AES-O-NRC-09-00017-0

AREVA Enrichment Services LLC  
Eagle Rock Enrichment Facility  
NRC Docket No: 70-7015

Subject: Supplement to Eagle Rock Enrichment Facility License Application - Depth to Groundwater Measurements from the Monitoring Wells on the Site for the Proposed Eagle Rock Enrichment Facility.

**Figure 3.4-13** Site Groundwater Potentiometric Surface Map  
**EAGLE ROCK ENRICHMENT FACILITY ENVIRONMENTAL REPORT**

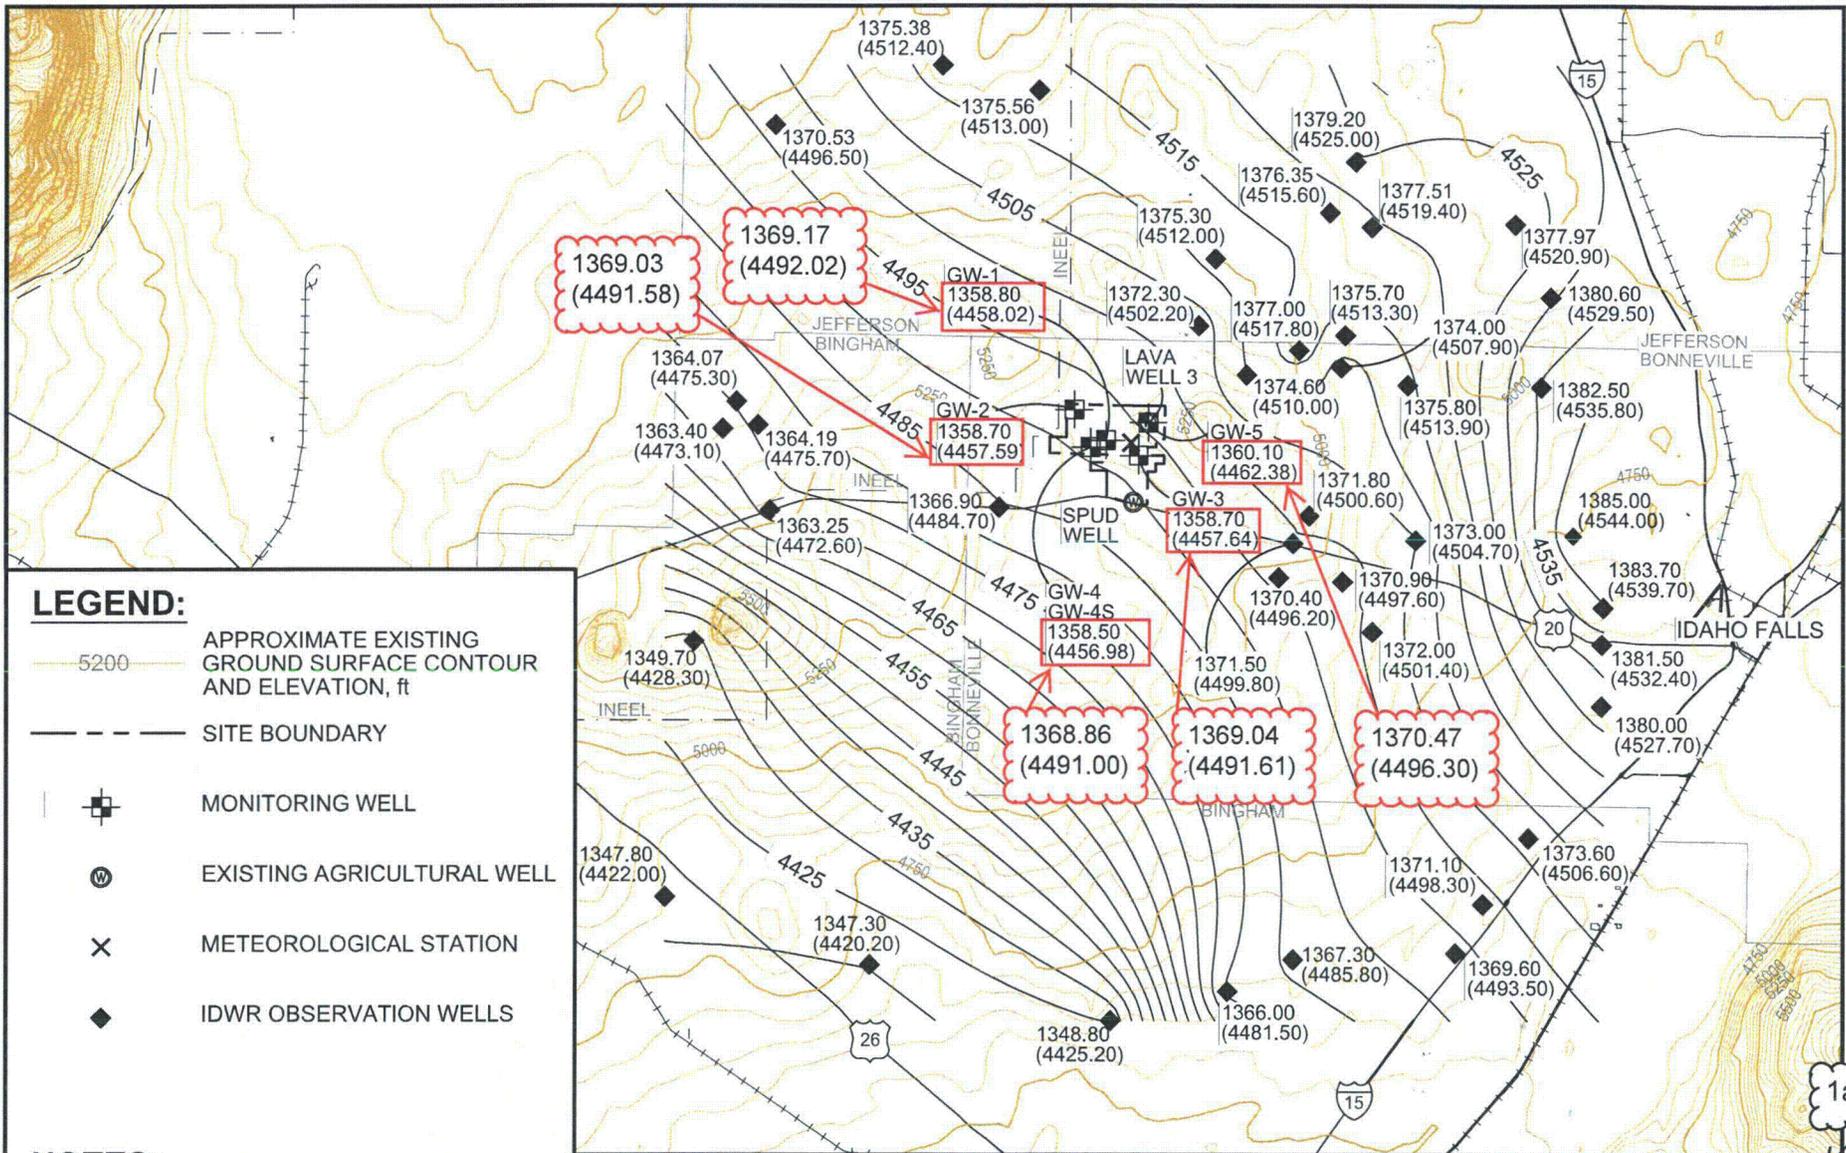
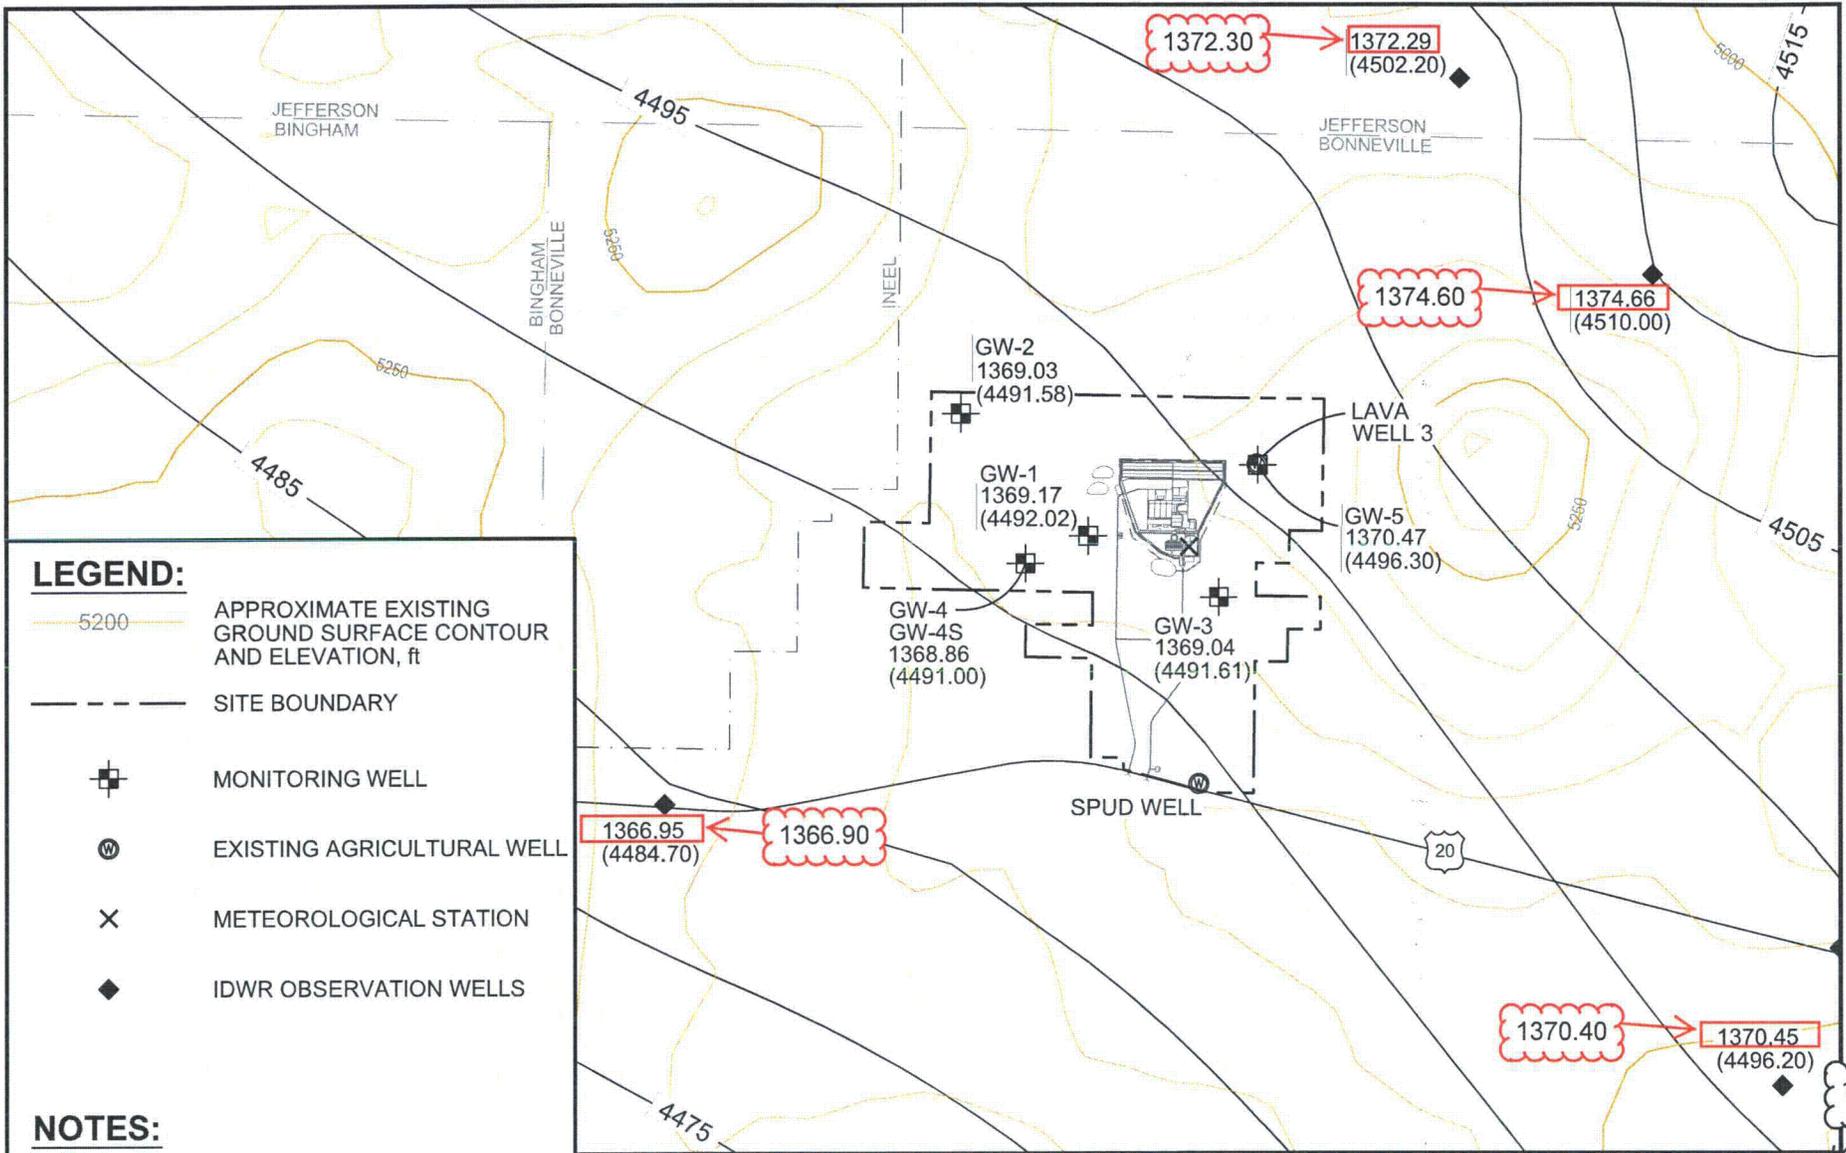
This supplement also corrects information presented in ER Table 3.4-13, Chemical Analyses for the EREF Site Groundwater, page 1 of 9, Revision 1, ER Figure 3.4-12, Regional Groundwater Potentiometric Surface Map, Revision 1, and ER Figure 3.4-13, Site Groundwater Potentiometric Surface Map, Revision 1. For ER Table 3.4-13, the depth to water measurements presented for monitoring wells GW-1, GW-2, GW-3, GW-4, and GW-5 are shown as below ground surface (bgs) measurements; however, these measurements are actually the depth to groundwater from the top of the PVC well casings. Since the PVC well casings extend above ground surface, the length that the PVC well casing is above ground surface (for each well) should have been subtracted from the measured depths to determine the below ground surface (bgs) water depths. For ER Figure 3.4-12, the groundwater elevations presented for monitoring wells GW-1, GW-2, GW-3, GW-4, and GW-5, are incorrect. The elevations presented should have been the same as those presented in ER Figure 3.4-13. For ER Figure 3.4-13, the elevations in meters for the IDWR Observation Wells shown on ER Figure 3.4-13, Revision 1, differ from the elevations in meters shown for the same locations on ER Figure 3.4-12 due to differences in rounding. The elevations in meters for the IDWR Observation Wells shown on ER Figure 3.4-13, are updated to match the elevations in meters shown for the same locations on ER Figure 3.4-12, Revision 1.

208.3  
(683.3)

219.2  
(719.1)

207.8  
(681.9)

200.7  
(658.4)

202.1  
(662.9)
